# **Release Notes**

| Product Name:           | KDS-EN6, WP-EN6, KDS-DEC6 |        |               |  |
|                         | Firmware                  | 7.7.11 | November 2022 |  |

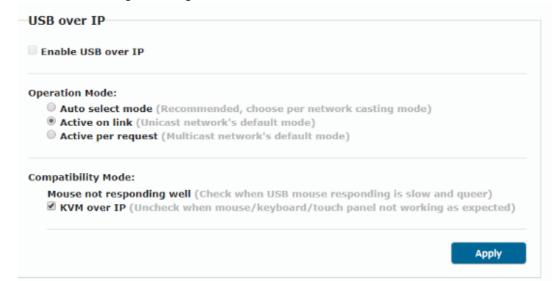
Enables interacting with multiple hosts via USB from one master KDS-DEC6 decoder connected to a keyboard and mouse.

1. On the webpage of each encoder and decoder configure the USB over IP section according to the figure below.

2. On the master decoder webpage, check both 1x4 and 2x2 setups

Figure 5: Label on Box

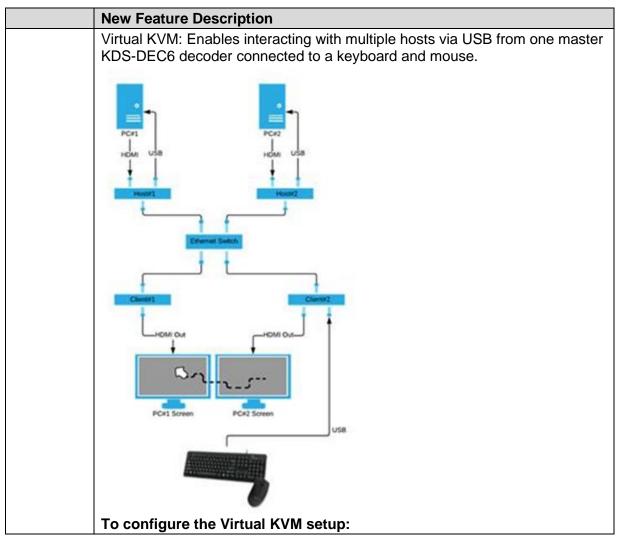
This update is compatible only with units labeled "HW version 2.0". To ensure interoperability between version 2.0 HW devices and version 1.0 HW devices, install FW 2.8 OP on the 2.0 HW devices and FW 2.8 on the 1.0 HW devices.
